# 2 LOT SUBDIVISION PLAN FOR

# DUBE PLUS CONSTRUCTION,

TAX MAP 283, LOT 11 HEMLOCK WAY, PORTSMOUTH, NH 03801 ROCKINGHAM CO.

**TAC Notice of Decision Response Comments**

SHT. 7 of 10

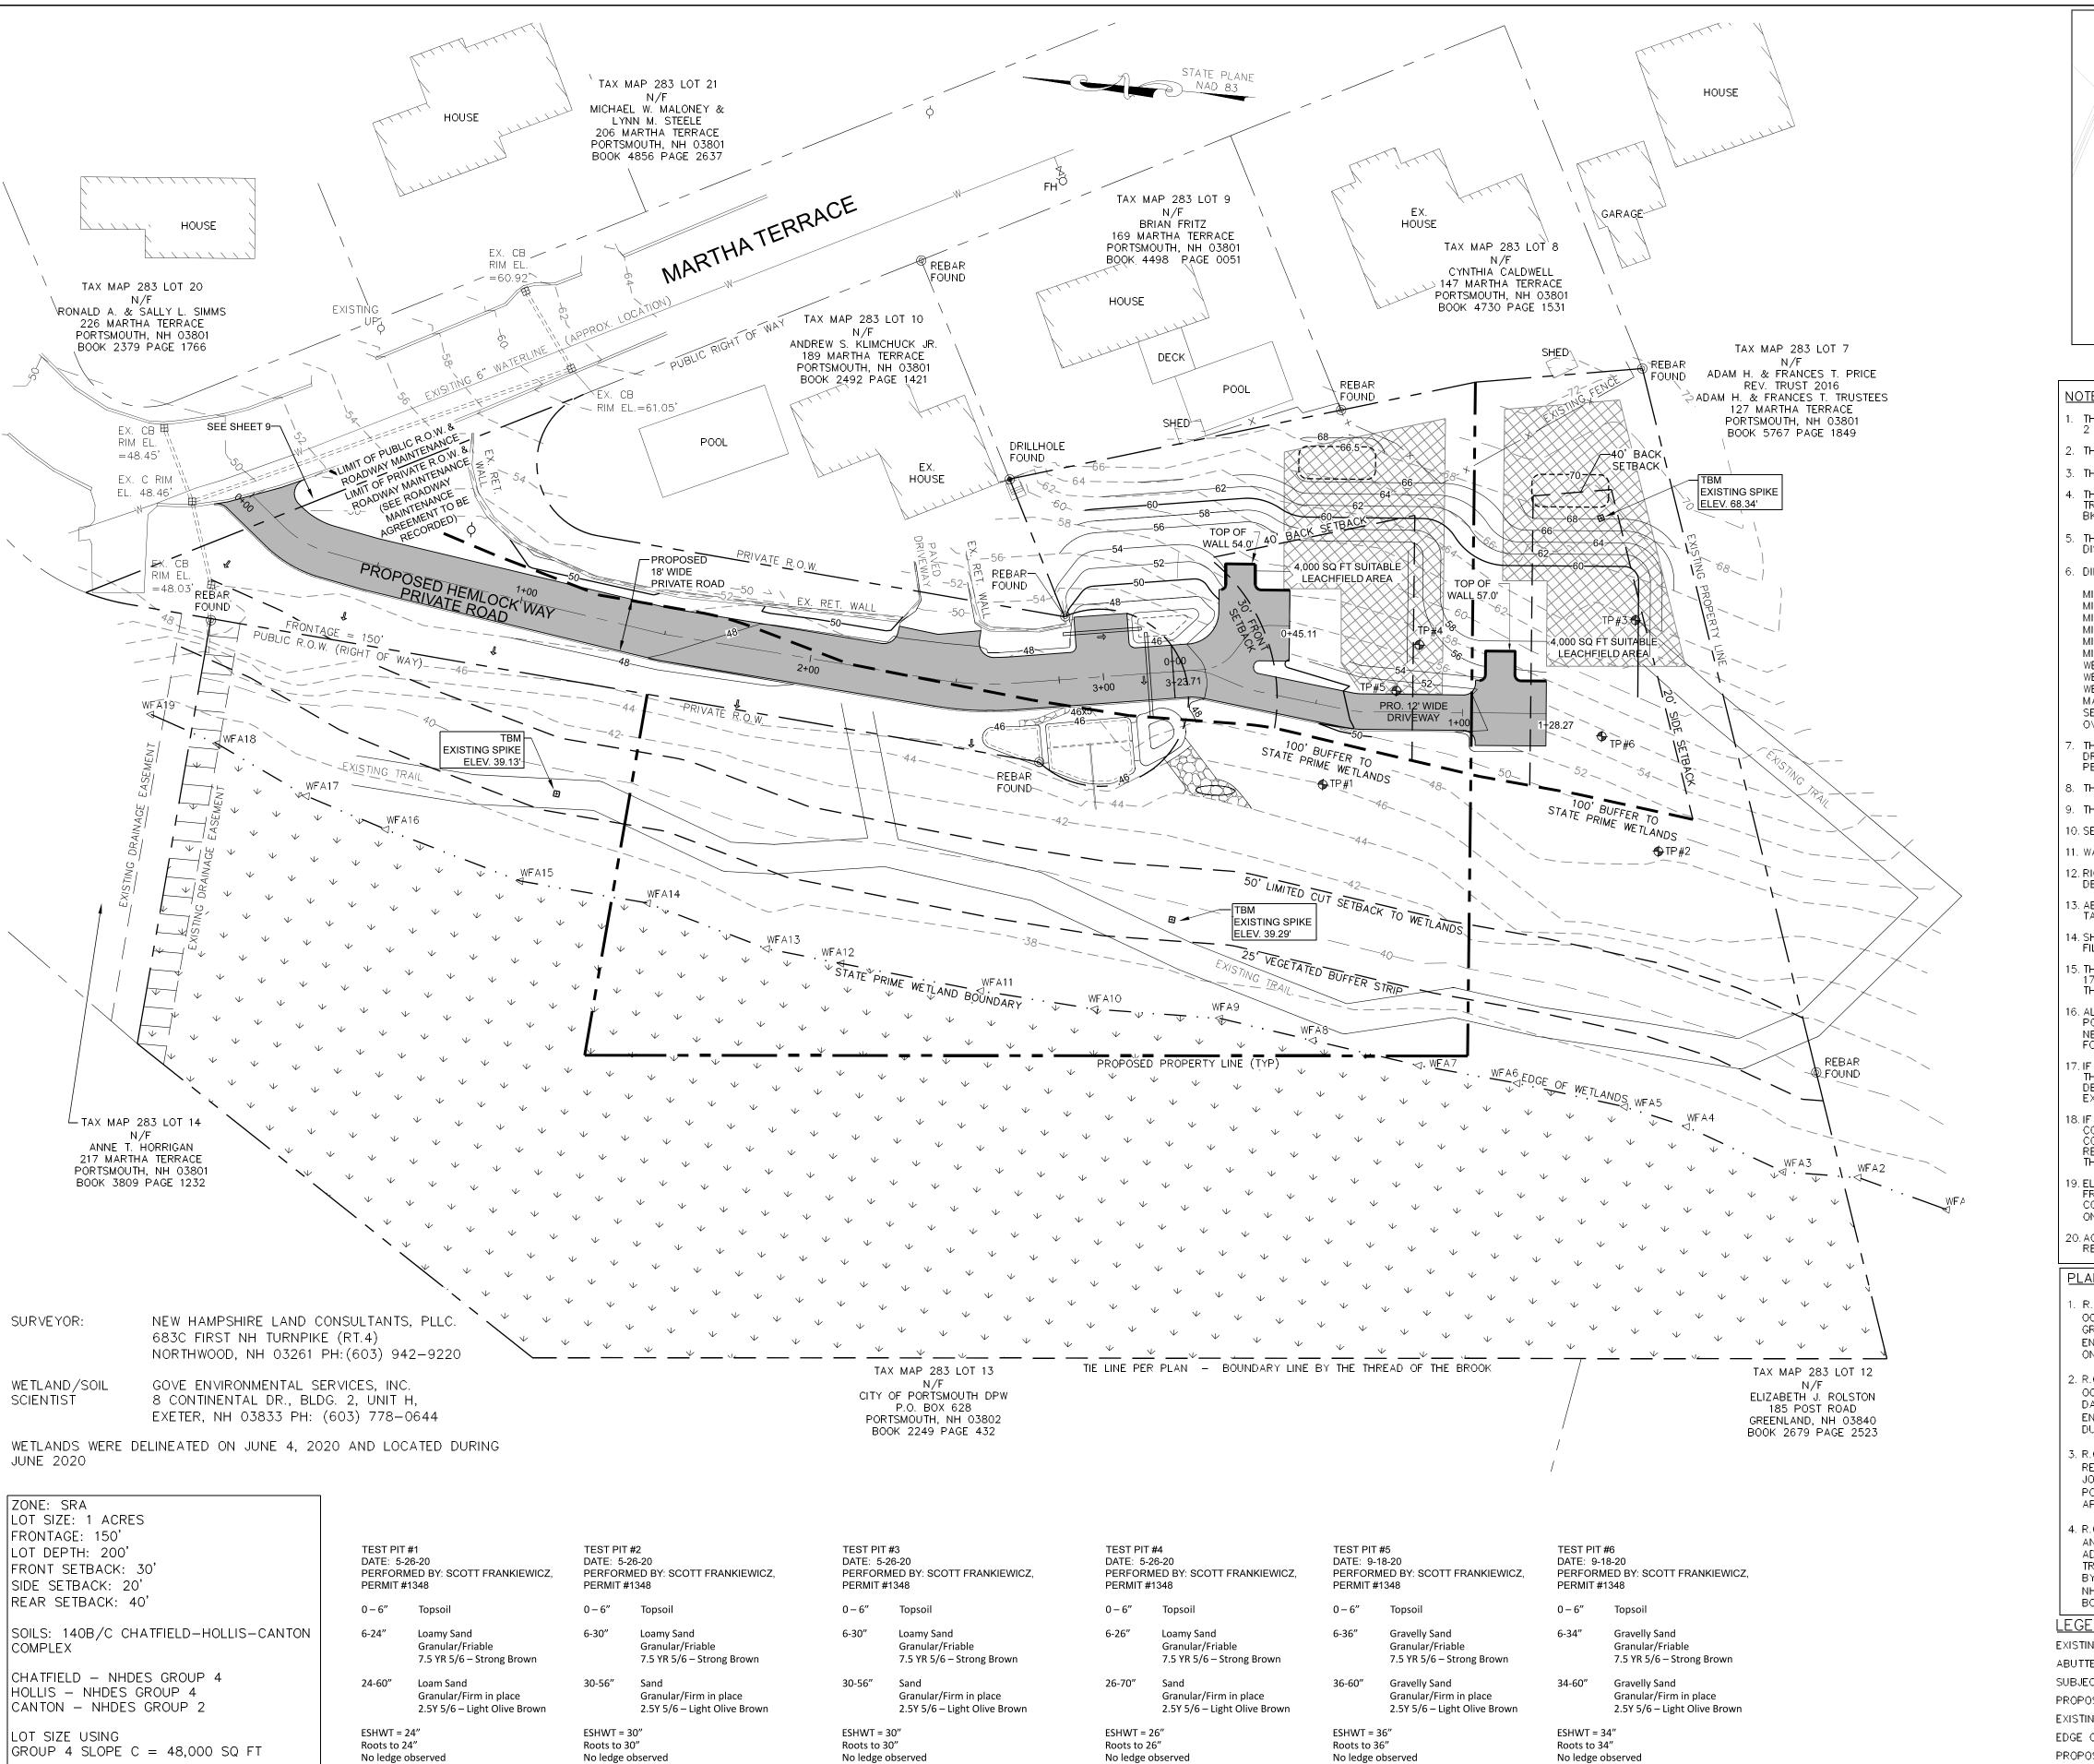
1. A note shall be added to the plan that if the Fire Department requires fire suppression in these homes, the Engineer of record shall review the water service(s) shown and show that this design will be sufficient for pressure and flow.

- 2. The applicant should update the plans to show two separate lines as approved by DPW. Response: The plans have been modified as shown on Sheet 7 of 10.
- 3. The plans should note an easement to the City to access the valves, leak detection and metering for water service.

Response: See Utility Notes as shown on Sheet 7 of 10.

Response: Sheet 9 of 10 provides an access and utility easement that shall benefit the City. Also see sheet 7 of 10 for Utility Notes.
